Access Compliance Report

Public Rights-of-Way

(Curb Ramps)

Intersection ID: 50593	Main Street: LUSTERLEAF_HOLLY_RD	Cross Street: GRAY_WILLOW_RD	Location: NW
ADA ID: CD3B344A0118	Ramp Type: Perp	Initial Pass/Fail: Fail	Overall Compliance: No
Codes/Mitigation Info/Possible Solution		Field Measurements/Component Compliance	
Severity Score: 8.75

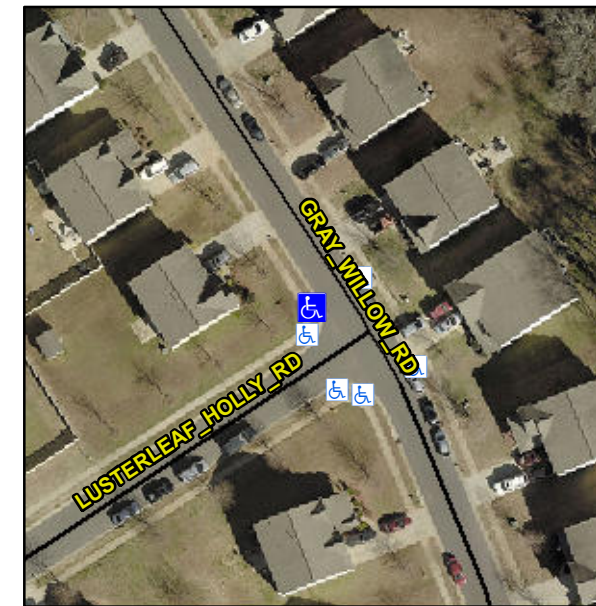
Not Found, R304.5.1

Remove & Replace Entire Ramp.
